Rezoning Transportation Analysis

Petition Number: 2025-128

General Location Identifier: 14117110, 14117112

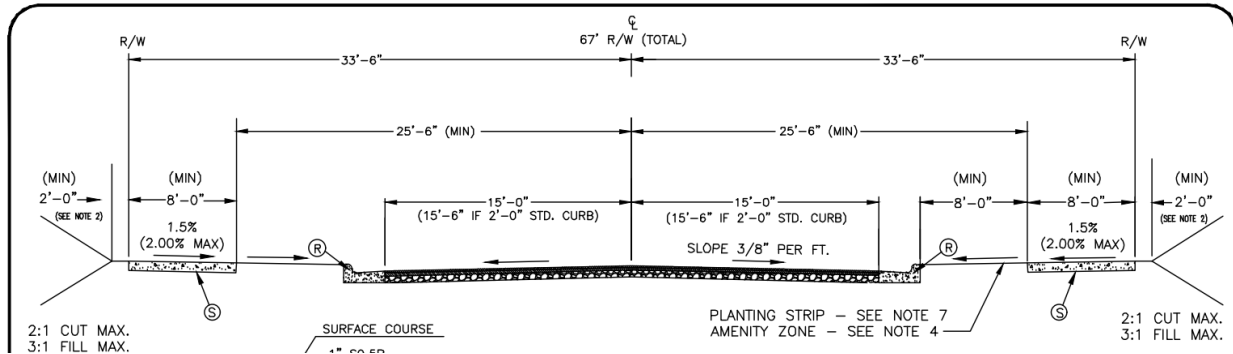
a. ~~Shopton Road: Location of future curb and gutter is to be located 27' from centerline.~~

~~2+ Avenue, Buffered/Separated Bike Lanes~~

~~Label and dimension the curb and gutter from the centerline for each road on the site plan.~~

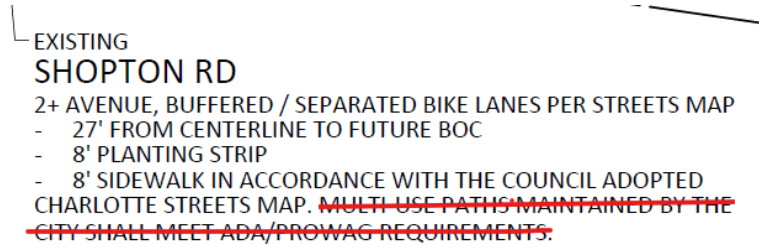
- ~~13. **Outstanding Issue From 12-22-25:** Revise site plan and conditional note(s) to construct 8-foot planting strips and 8-foot sidewalks on Shopton Road and internal public streets. The site plan shall label and dimension both items from the back of curb and gutter or edge of pavement. Add conditional note The entire facility must be outside of the right of way and within a public access easement. Add conditional note committing to construction and maintenance of the 8-foot sidewalks on Shopton Road and internal public streets.~~

Clarifying Comment 01-22-26: This project is located within the Extraterritorial Jurisdiction (ETJ) and thus the Right-of-way line should be dedicated to the front face of sidewalk with a public access

easement (PAE) dedicated over the sidewalk for all public roadways. Revise site plan and conditional notes to adjust the Right-of-way dimensions.

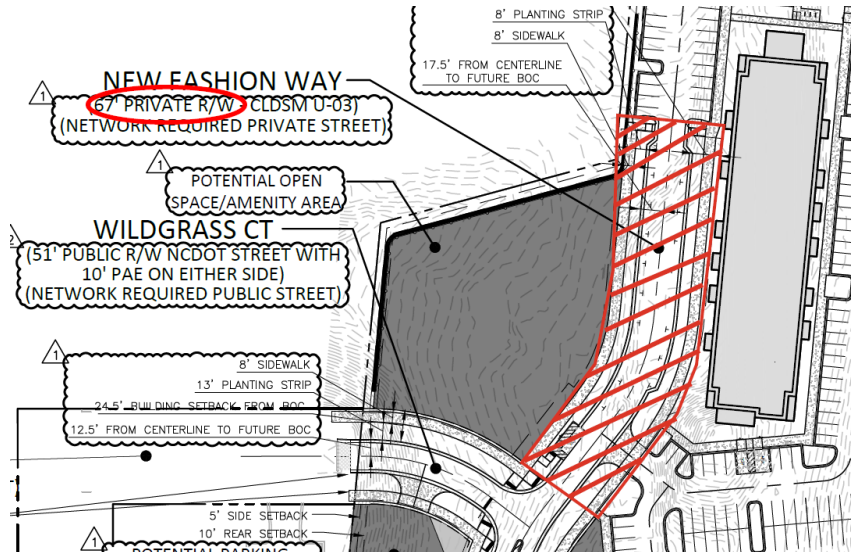
16. ~~New Comment 01-22-26:~~ Revise site plan and conditional notes to show New Fashion Way will have public access easement (PAE) in place of private Right of way. Identify northern limits of PAE along New Fashion Way.

~~Clarifying Comment 02-19-26:~~ Show the limits of the Public Access Easement on the plan and label as Public Access Easement (PAE) instead of private right of way.

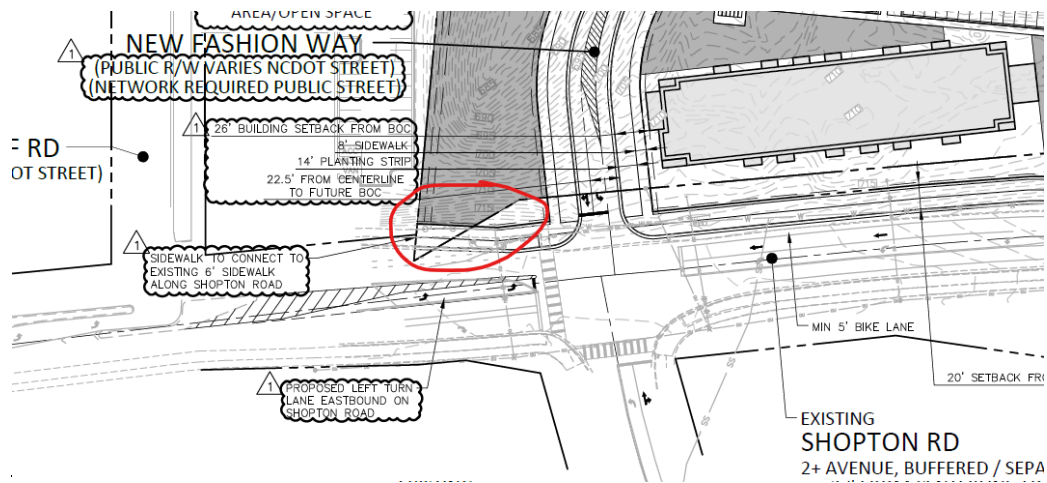
17. ~~New Comment 01-22-26:~~ Revise site plan to clean up ROW along Shopton Road to show appropriate ROW along entire frontage.

Clarifying Comment 02-19-26: Add dimension of ROW to the west of New Fashion Way to show that ROW meets minimum requirements along Shopton Road, and it will also show that the new and existing sidewalk are located within right of way for the entire frontage. Existing sidewalk along property frontage must be within Right of way or sidewalk utility easement (SUE).

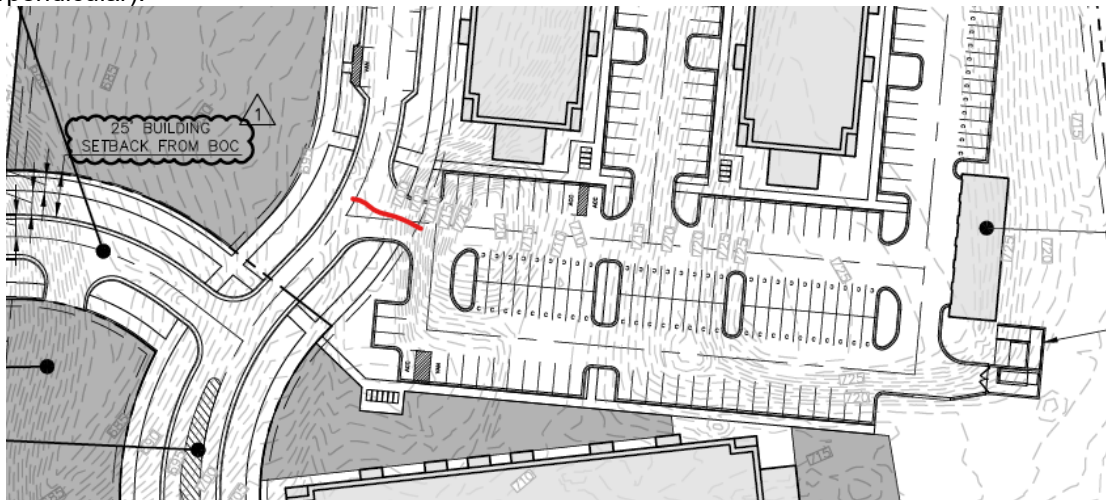
18. ~~New Comment 01-22-26:~~ Revise site plan to align driveway intersection at 90-degree angle (perpendicular).

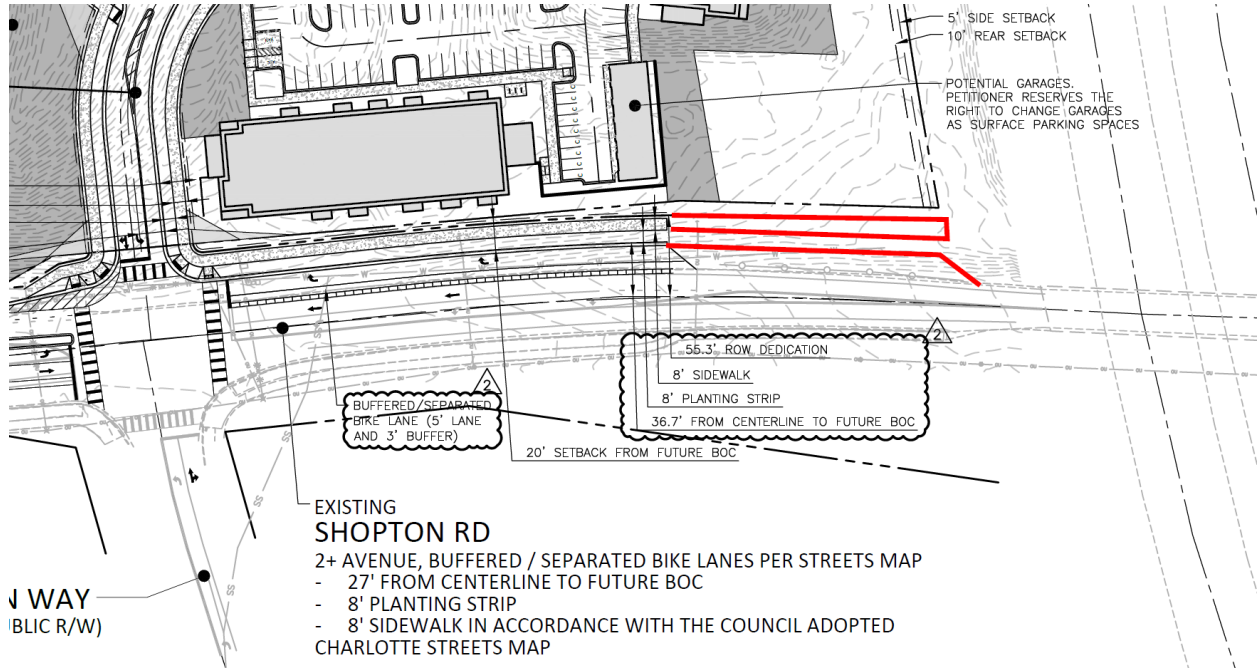
19. ~~New Comment 02-19-26:~~ ~~Revise site plan to install roadway, bike lanes, and streetscape improvements along entire project frontage. You can add a note stating that limits of improvements will be coordinated with NCDOT/CDOT during permitting due to existing bridge and/or site conditions.~~

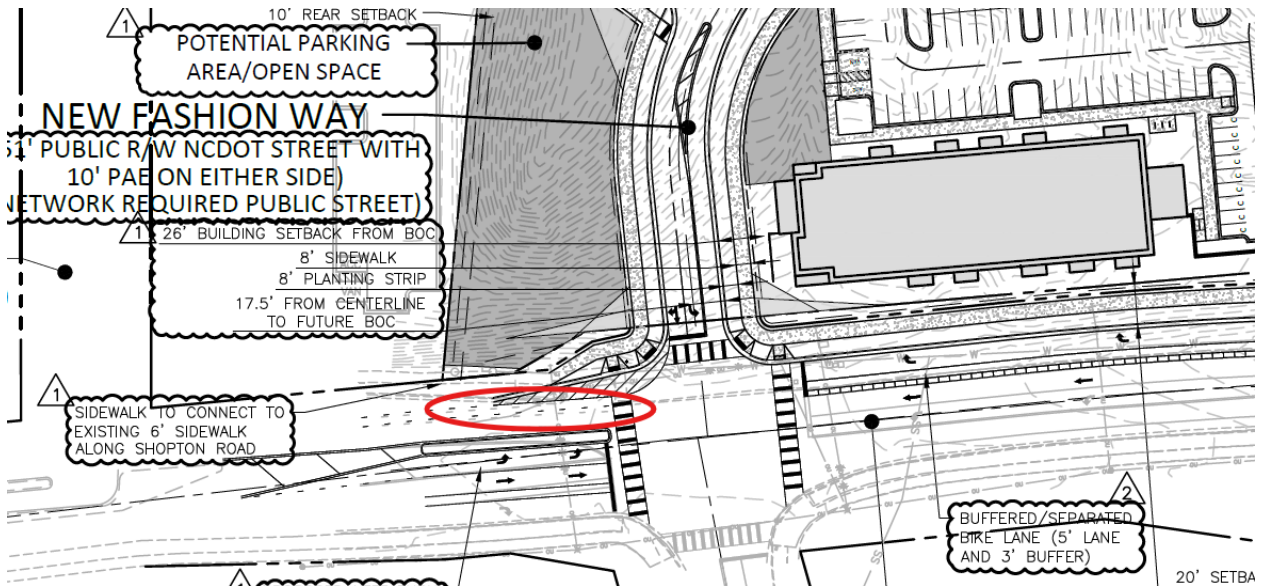
20. ~~New Comment 02-19-26:~~ ~~Revise site plan to install buffered bike lane along entire frontage. Show buffered bike lane west of driveway along project frontage. Can add a note to coordinate with CDOT/NCDOT during permitting on bike lane transition.~~

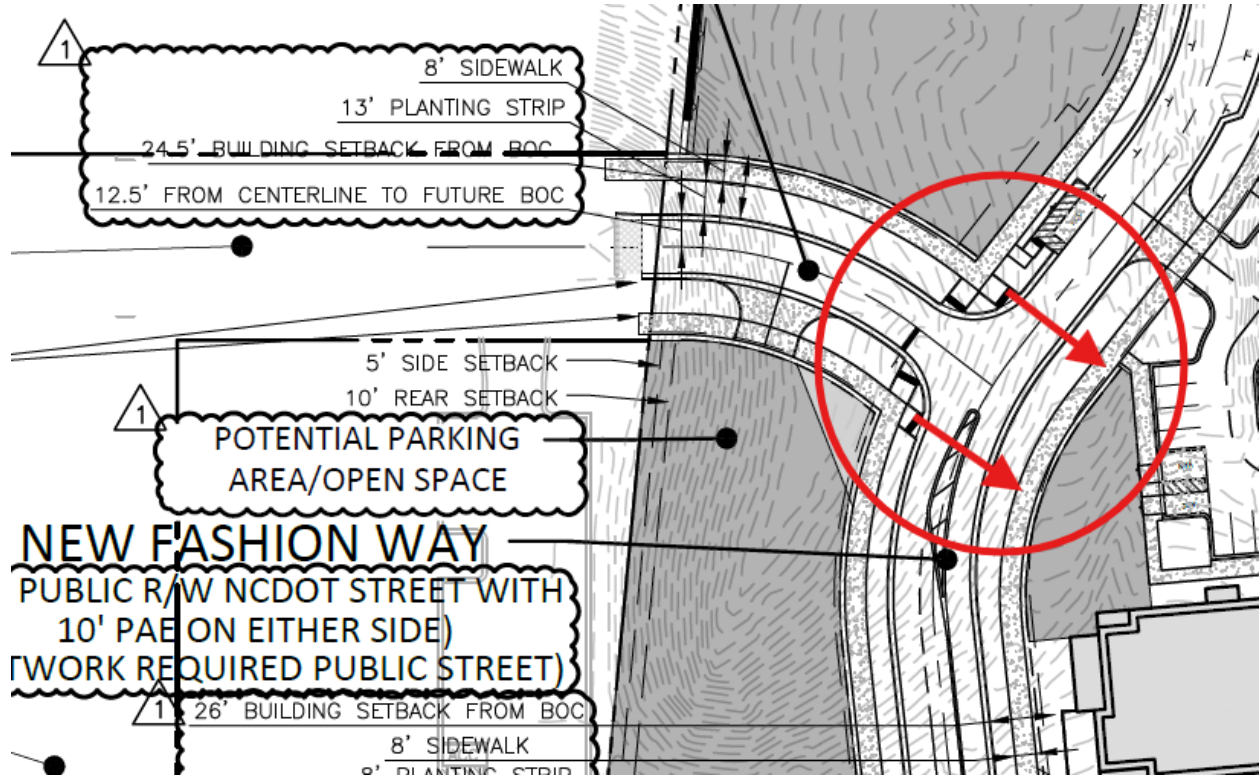
21. ~~New Comment 02-19-26:~~ Revise site plan to show receiving ramps across New Fashion Way.

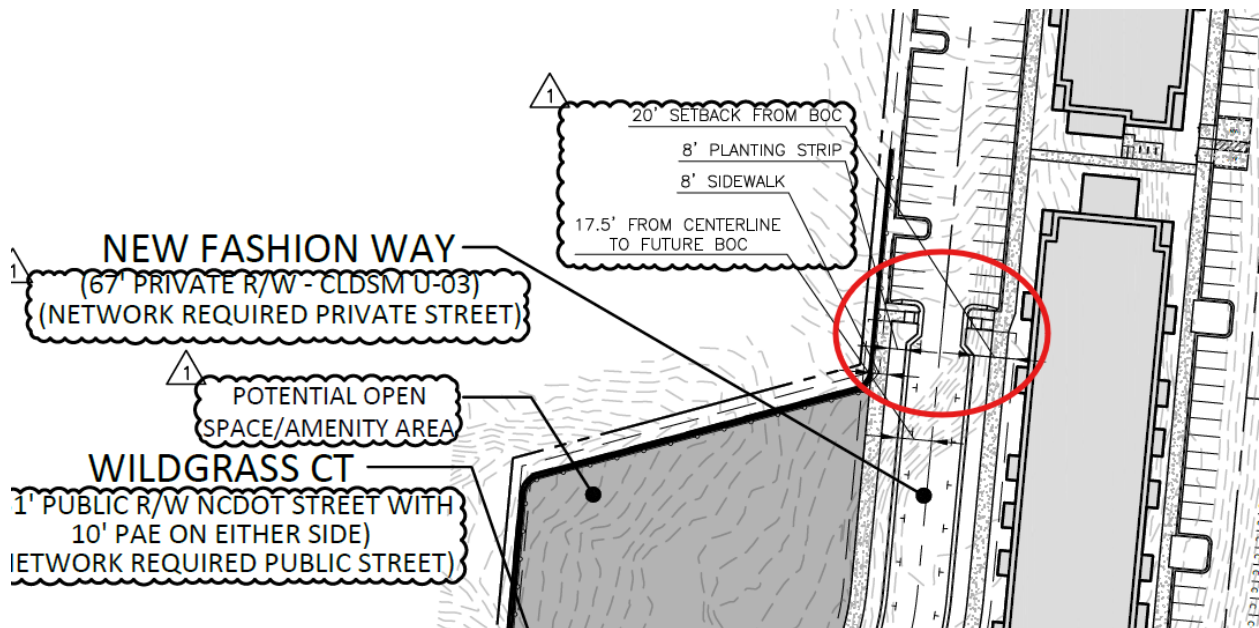
22. ~~New Comment 02-19-26:~~ CDOT is coordinating with internal groups regarding the end of road treatment on the network required private street. If determination is reached before next submittal, Chris Manno with CDOT will reach out to petitioner and provide any comments/requirements.
